ATMEL

Circuit Analysis Report

Test IC	AT86RF231	
Crystal	Holder	NX2520SA
	Frequency	16.000MHz
	Load capacitance	CL=8pF[IEC] (Current) CL=10pF[IEC] (Suggested)
	NDK Spec. No.	STD-CSW-5(J) (*J:CL=10pF[IEC])
Test Circuit	IC	ATRF231 58901-03 1114 PH 0T7966-1
	VDD	+3V / +1.8V
	PCB	TB1_XMEGA_231 AVR2067 - Crystal Characterization for AVR RF

2. CIRCUIT DIAGRAM

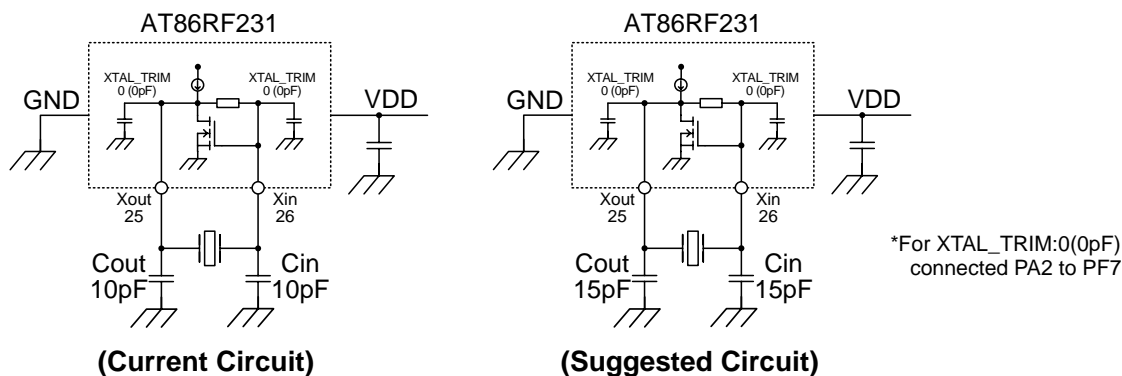
- 1) This crystal unit requires negative resistance of $-R = 900\Omega$ minimum for stable oscillation
- 2) Circuit characteristics

- 3) Although the negative resistance of the current circuit is over our target, it seems too large.
- 4) In order to improve negative resistance, we recommend changing external capacitance values from Cout/Cin=10pF/10F to **Cout/Cin=15pF/15pF**. Besides, we recommend changing crystal load capacitance value from CL=8pF to **CL=10pF** in order to improve frequency deviation.

Circuit	Cout/Cin	XTAL_TRIM (Internal Cap)	Frequency deviation dF/F	Negative Resistance -R	Drive Level DL	Startup time Tstr
Current	10pF/10pF	0 (0pF)	+2ppm (CL=8pF[IEC])	3340 Ω	Less than 10uW	2ms
Suggested	15pF/15pF	0 (0pF)	-4ppm (CL=10pF[IEC]) Ref.: -22ppm (CL=8pF[IEC])	1900 Ω	Less than 10uW	2.5ms
